# DEVIATION REQUEST AND DECISION FORM

## PROJECT INFORMATION – VILLAGE MAIN STREET DEVIATION REQUEST

Project Name : Mayberry, Colorado Springs Filing No. 1  
 Schedule No.(s) : 34000-00-259, -260, -349, -350, -356, -362  
 Legal Description : Mayberry, Colorado Springs Filing No. 1

**(VILLAGE MAIN STREET) TYPICAL COMMERCIAL SECTION**

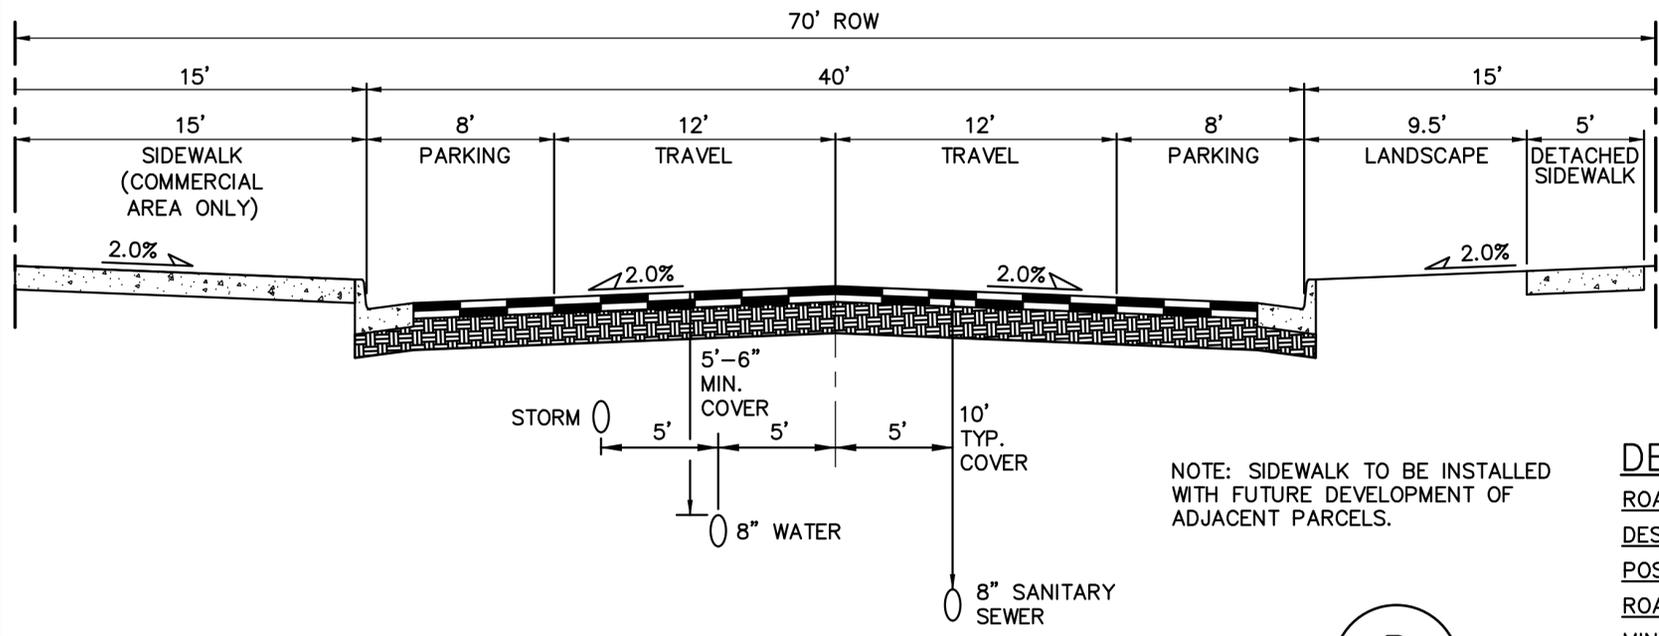
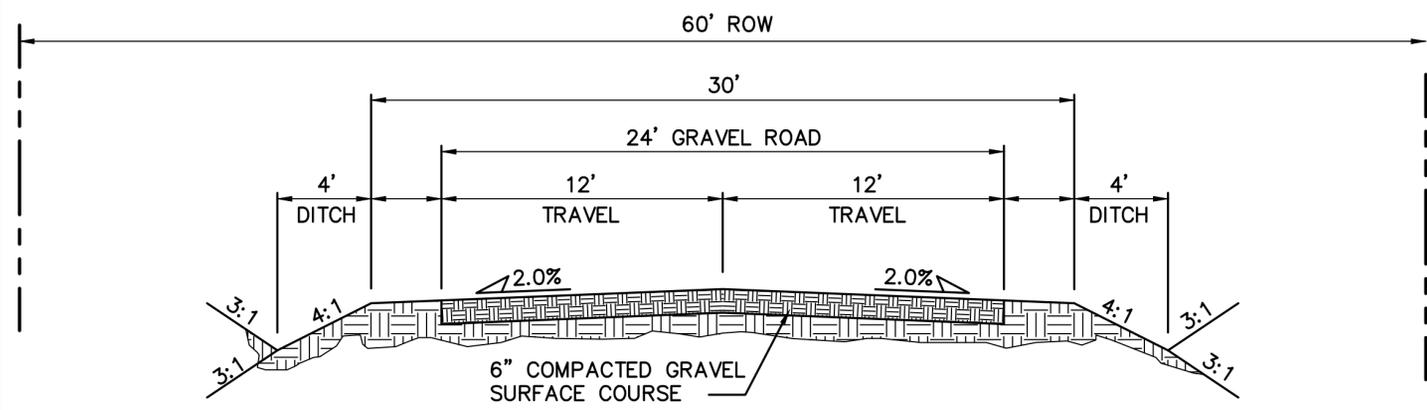
Village Main Street is ultimately classified as an Urban Non-Residential Collector through the Town Center area, and an Urban Residential Collector through the residential areas. The proposed deviations consist of modified cross-section elements including a 36-foot asphalt width for the Non-Residential Collector and a 30-foot asphalt width for the Residential Collector road segments, as well as an interim gravel secondary access road section during the initial phase of development. The proposed deviations are depicted on the Typical Road Section Drawings (Sections A-C, Sh. TY1).

The current ECM standard is a 48-foot asphalt width for an Urban Non-Residential Collector and a 36-foot asphalt width for an Urban Residential Collector. The narrower road widths are consistent with new urbanist land planning as approved in the Ellicott Town Center PUD. Minimum travel lane widths of 12 feet are provided in accordance with current ECM standards.

The proposed deviations will reduce traffic speeds and provide for enhance traffic calming.

The interim gravel segment shall be paved to a 20-foot minimum width, plus 2-foot gravel shoulders, upon traffic counts exceeding 200 ADT.

Paving of Village Main Street shall be provided by the developer at the time traffic counts exceed 200 ADT. Traffic counts shall be performed upon buildout of each phase/filing of the overall development or sooner if determined by the ECM Administrator.

**TYPICAL URBAN ARTERIAL ROAD SECTION**  
(ULTIMATE LOG ROAD AT COUPLER)

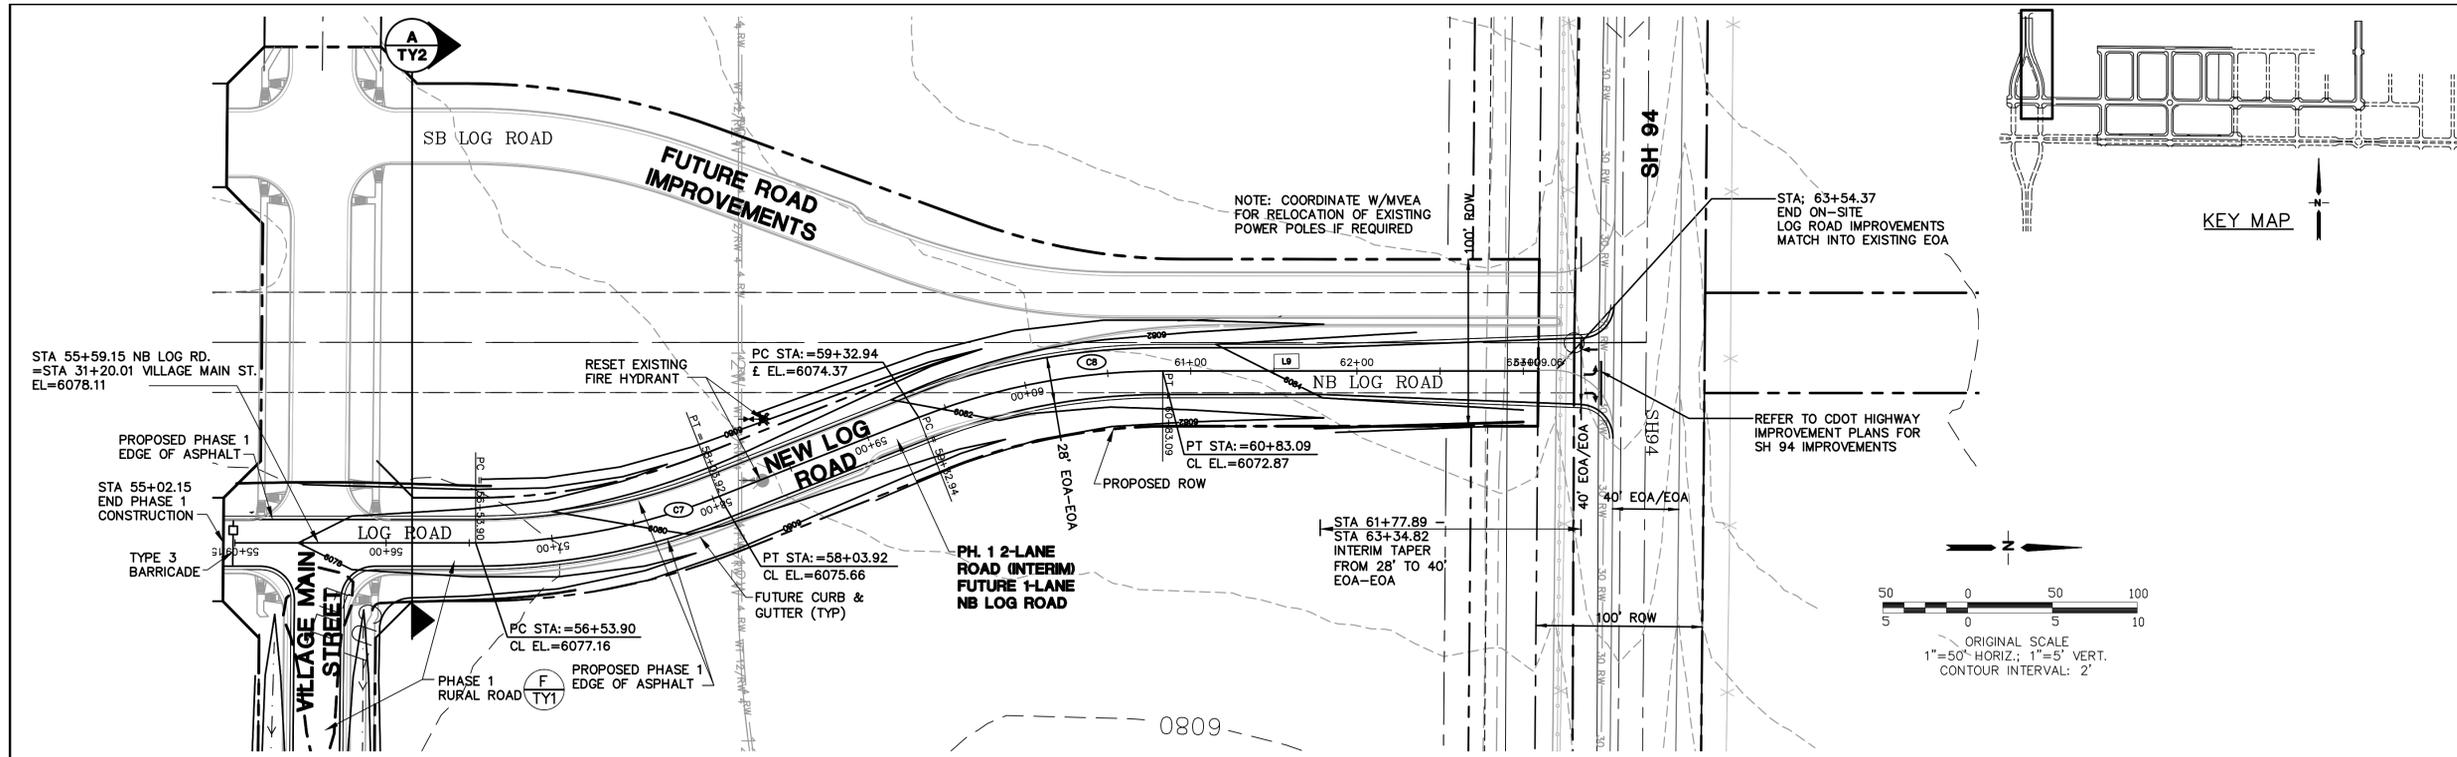
New Log Road is ultimately classified as an Urban Minor Arterial roadway. The proposed deviations consist of modified cross-section elements including 15-foot attached sidewalks, bike lanes permitted, and on-street parking allowed for the ultimate road section, as well as an interim rural asphalt road section during the initial phase of development. The proposed deviations are depicted on the Typical Road Section Drawings (Sh. TY1-TY2).

The ultimate road section of New Log Road consists of a 2-lane, 1-way Couplet through the Town Center area in accordance with the approved Ellicott Town Center PUD, as depicted in Section A, Sheet TY2.

This request has been determined to have met the criteria for approval. A deviation from Section 2.3.2 of the ECM is hereby granted based on the justification provided

**NB NEW LOG ROAD  
PLAN & PROFILE**  
(STA: 55+00 TO STA: 64+00.00)

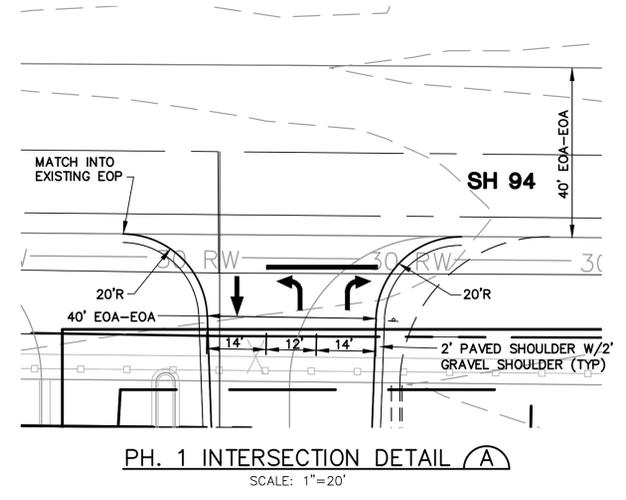
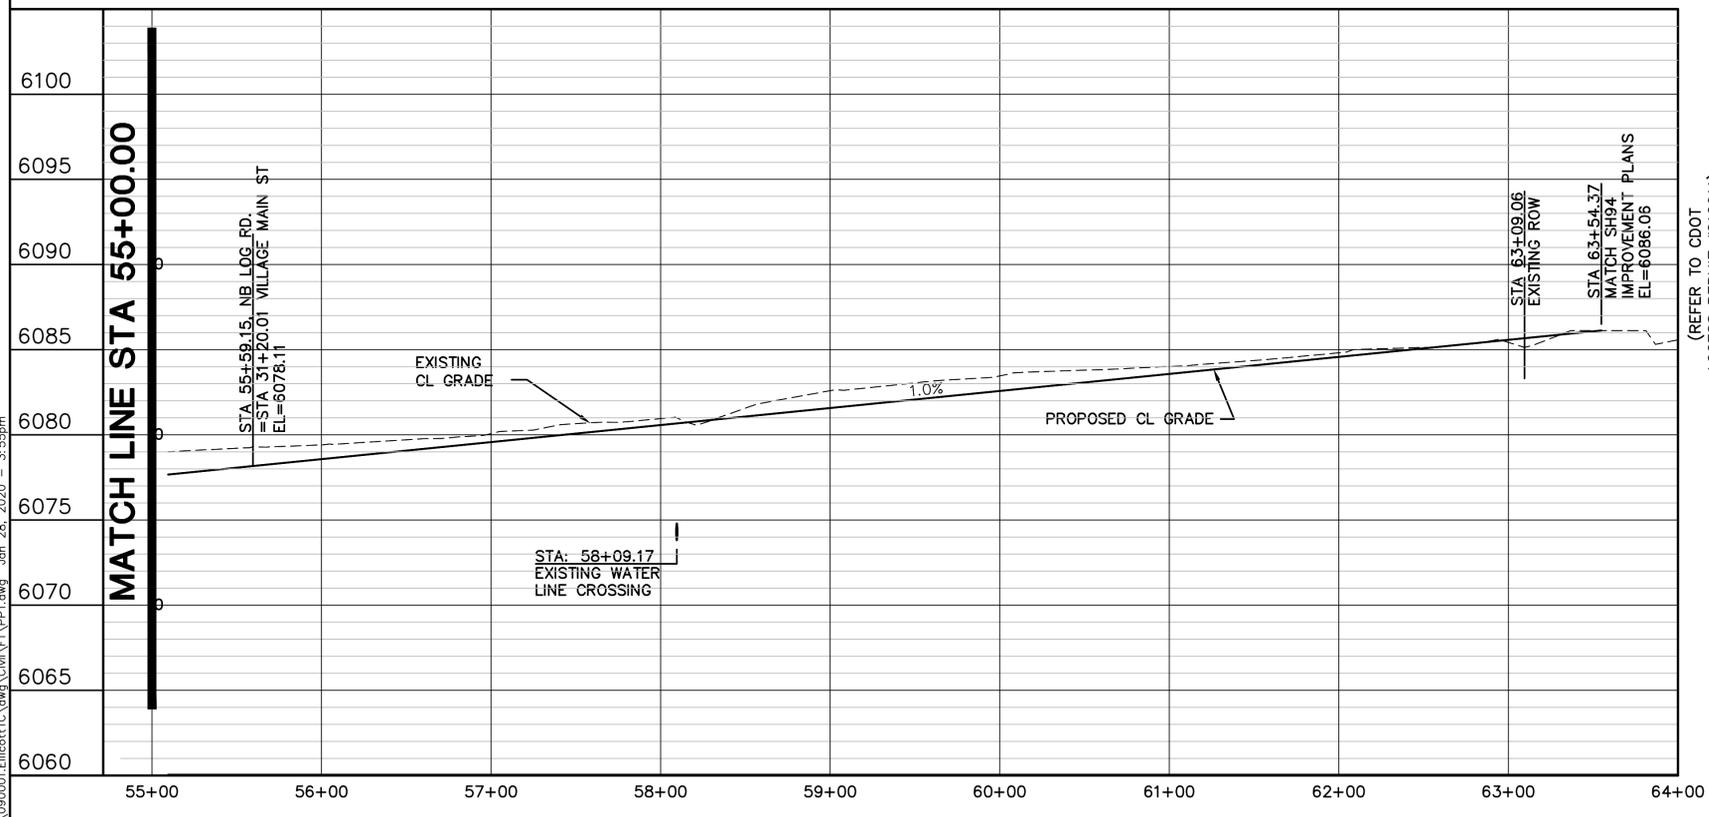
The ECM-prescribed minimum horizontal centerline radius for an urban minor arterial is 565 feet. This deviation request also allows for a slightly reduced minimum centerline radius of 527 feet at couplet transitions as depicted on the attached Plan & Profile Drawing (Sh. PP1).

The proposed minimum centerline radius of 527 feet is only a slight reduction compared to the standard minimum radius of 565 feet.

TEMPORARY POND C2.8 PLAN

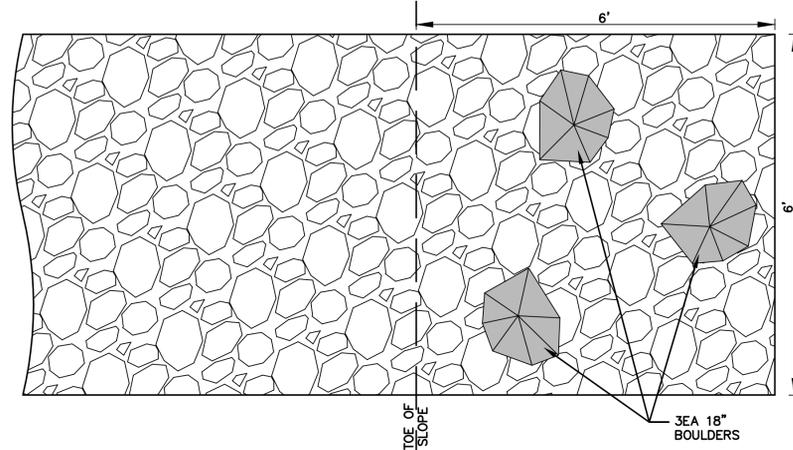
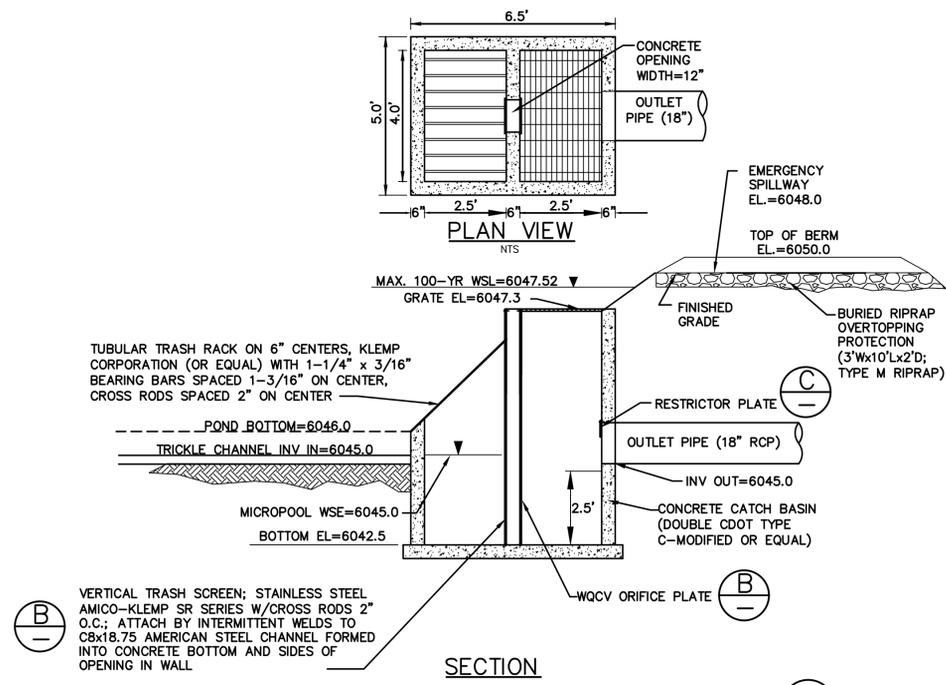
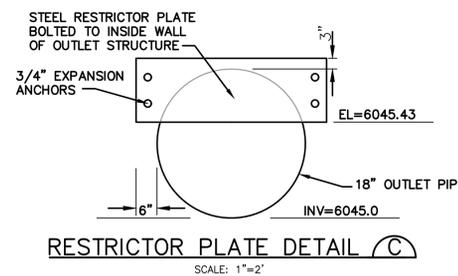
This deviation request accounts for non-standard design aspects of the proposed Temporary Detention Basin C2.8. This detention basin has been designed as a temporary full-spectrum detention basin which will mitigate developed drainage impacts from parts of Filing No. 1 and No. 2 during the initial phases of development. Once the downstream Detention Basin D is constructed during future phases of development, this temporary detention basin will no longer be needed. Based on the temporary nature of this interim detention pond, the design does not include a forebay that would be included in a permanent detention pond, but a concrete trickle channel will be provided. The non-standard design components are justified by the temporary nature of this detention basin.

Based on the temporary nature of this interim detention pond, the design does not include a forebay that would be included in a permanent detention pond, but a concrete trickle channel will be provided. The non-standard design components are justified by the temporary nature of this detention basin.

Forebays are standard requirements for permanent detention basins, but construction of these features would be wasteful for an interim detention basin, which will ultimately be removed when the larger downstream detention pond is constructed. The proposed temporary detention basin will include a concrete trickle channel, standard FSD outlet structure, and associated discharge facilities to properly mitigate drainage impacts from the applicable development area.

This request has been determined to have met the criteria for approval. A deviation from Section 1.7.3 of the ECM is hereby granted based on the justification provided.

SHEET: **TY2**

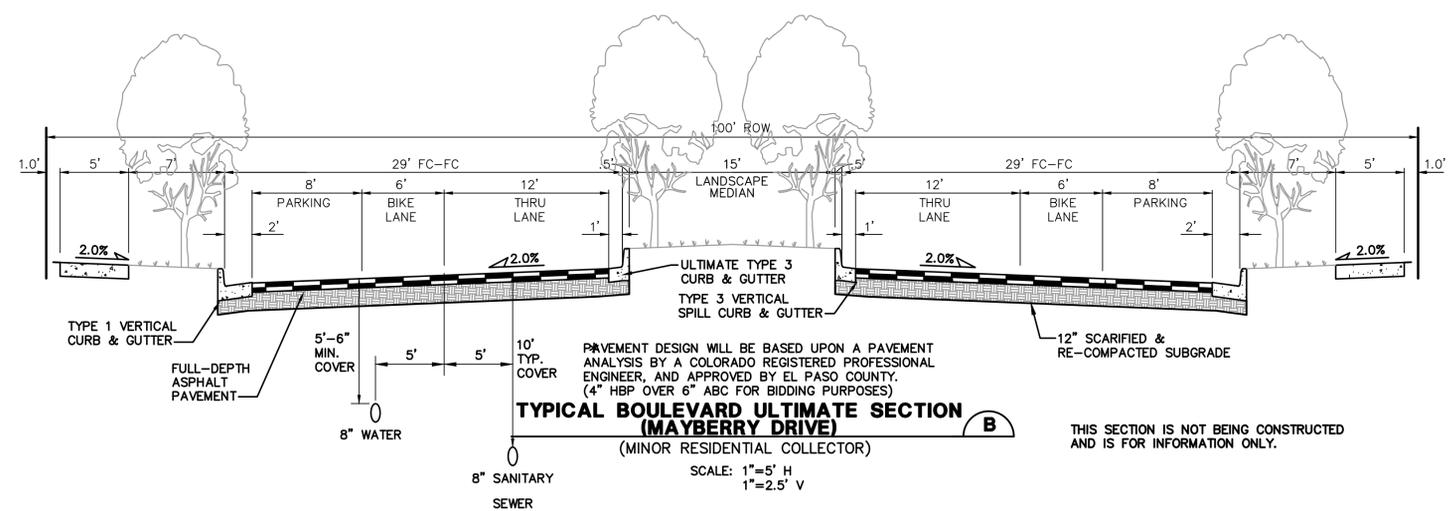
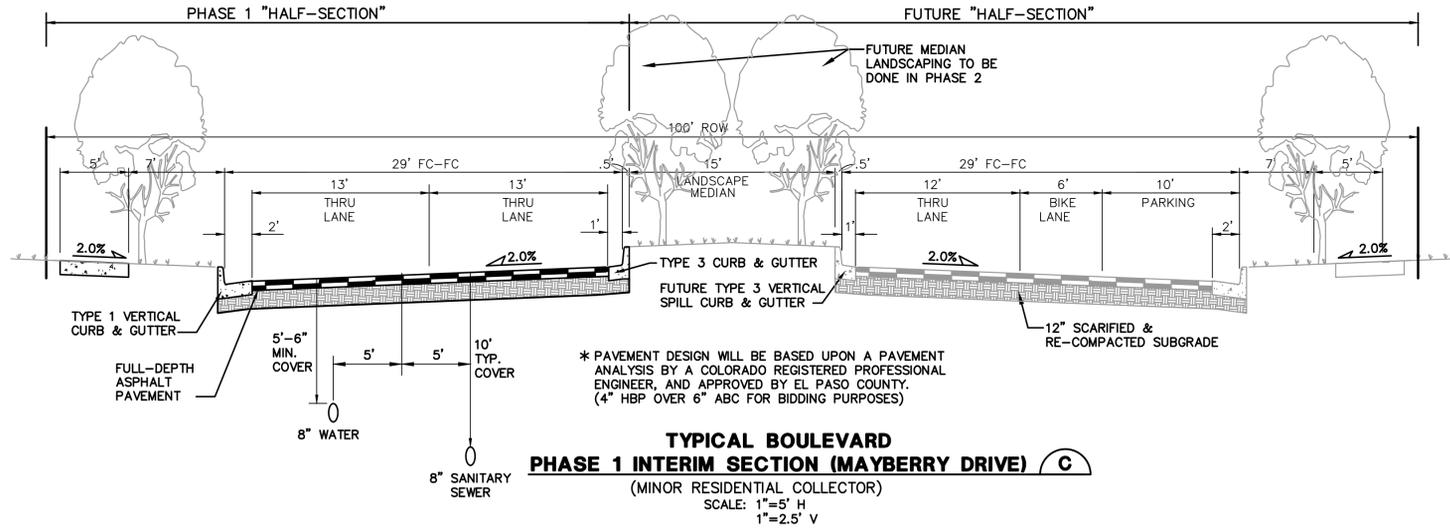
Mayberry Boulevard is classified as an Urban Residential Collector. The proposed deviations consist of modified cross-section elements including an ultimate divided section with landscaped median, and a Phase 1 half-section with a 29-foot asphalt width. The proposed deviations are depicted on the Typical Road Section Drawings (Sections B-C, Sh. TY2).

The current ECM standard is a 36-foot asphalt width for an Urban Residential Collector. The narrower road widths are consistent with new urbanist land planning as approved in the Ellicott Town Center PUD. Minimum travel lane widths of 12 feet are provided in accordance with current ECM standards.

All median cover designs shall be submitted to PCD Engineering for approval prior to installation. No loose rock or other loose material will be allowed. All medians less than 10' shall provide plow-able median noses per EPC criteria. Approval of this deviation does not constitute approval of the installation of trees in the public ROW (either in the median or adjacent to the road at the sidewalk). If trees are to be approved in the public ROW specific sight visibility criteria will be required to be addressed.

The median cover shall be installed and maintained by the Metro District, and a License agreement for such plantings shall be required prior to installation of the plantings, and preliminary acceptance of the street improvements.
